PERMIT

05-353653

ON-SITE SEWAGE DISPOSAL SYSTEM HOWARD COUNTY HEALTH DEPARTMENT BUREAU OF ENVIRONMENTAL HEALTH

SUBDIVISION: Whites Estates LOT NUMBER: 1

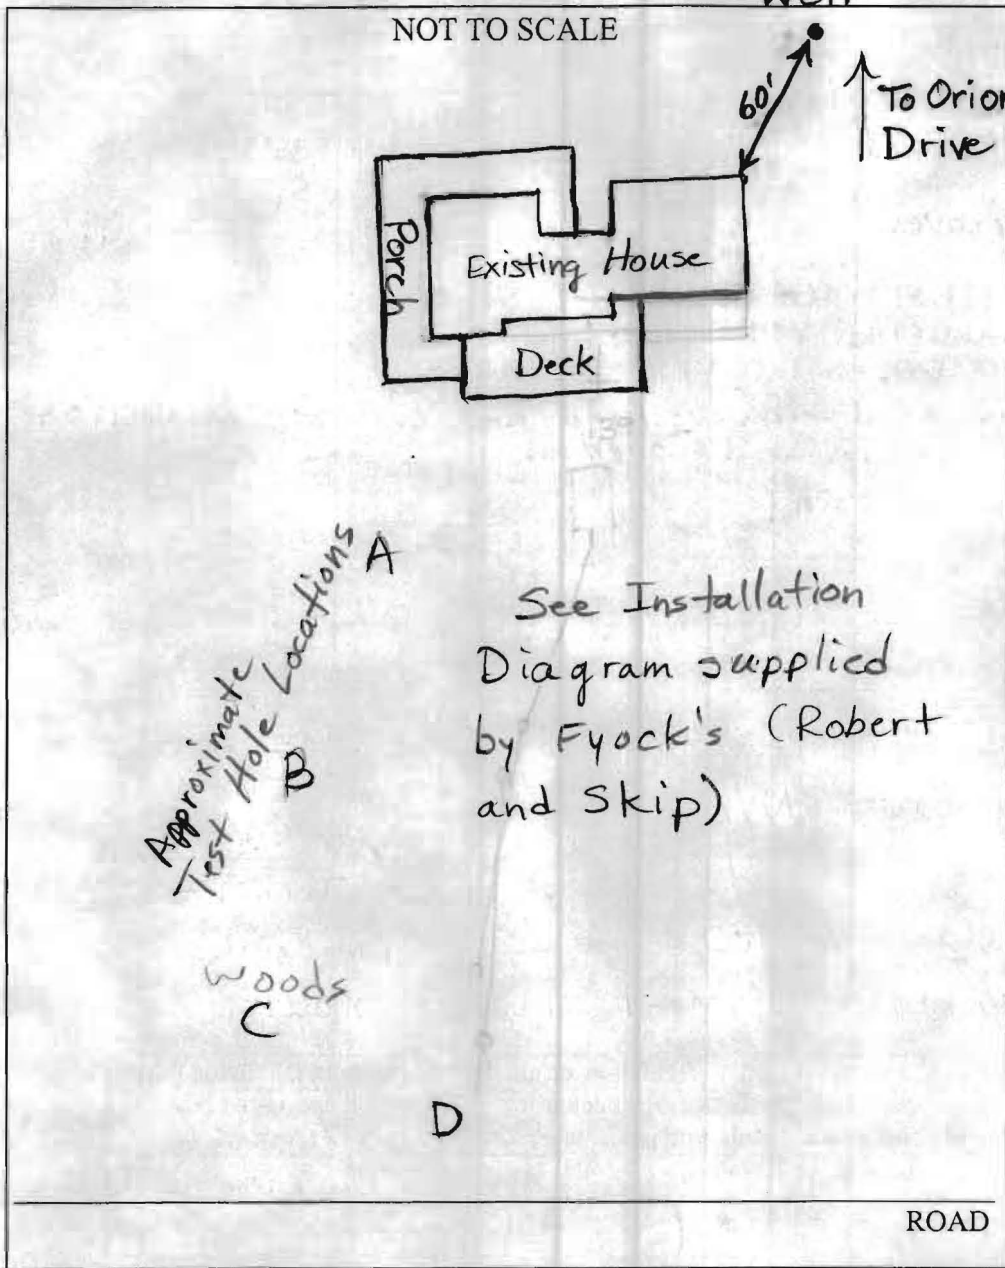
Fyock's supposed to install during weekend and call for inspection on Monday. Never called in and covered.

SQUARE FEET PER BEDROOM: 180 Inlet raised to 3.5'

LINEAR FEET OF TRENCH REQUIRED: 200 - 1' sidewall? Depth 4.5' by Fyock crew.

Drawing
Courtesy of
Skip and Robert
(Fyock)

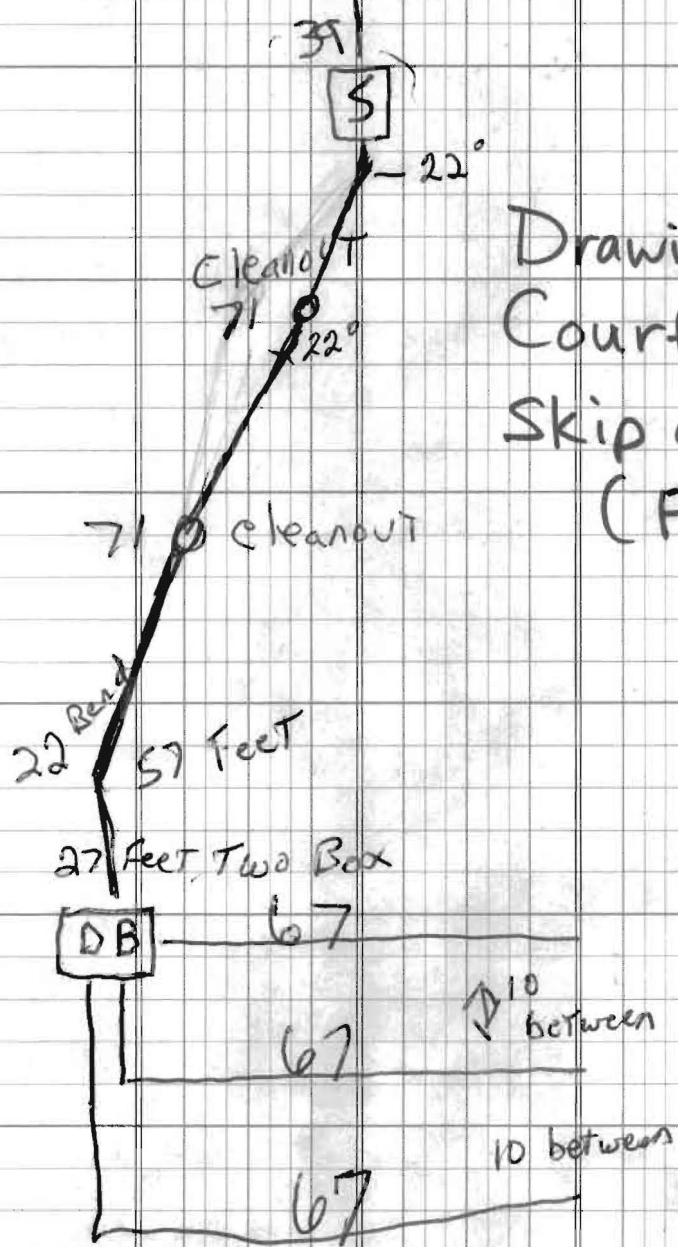
* System installed during weekend without inspection, cannot approve. See diagram supplied by Fyock crew. Future repair area will probably be in part of front yard opposite of well. This area not tested. ← Or directly above this repair? ←

4/14/04 System installed and covered during prior weekend. Fyock (Skip) said that had to cover because of weather. Skip said that homeowner was present when system installed. The trench inlet and bottom was raised because Skip said a well was downhill that we hadn't noticed during the initial visit to the lot. I visited site, an unconnected well was indirectly downhill of the trench installation area. Should be O.K.

Well ~125' from trenches according to Skip. Skip said that trench bottom material was good although sidewall area probably reduced. Did not run trenches past test hole D per Skip.

3' wide
3.5'-4.5'
~ 125' from downhill well
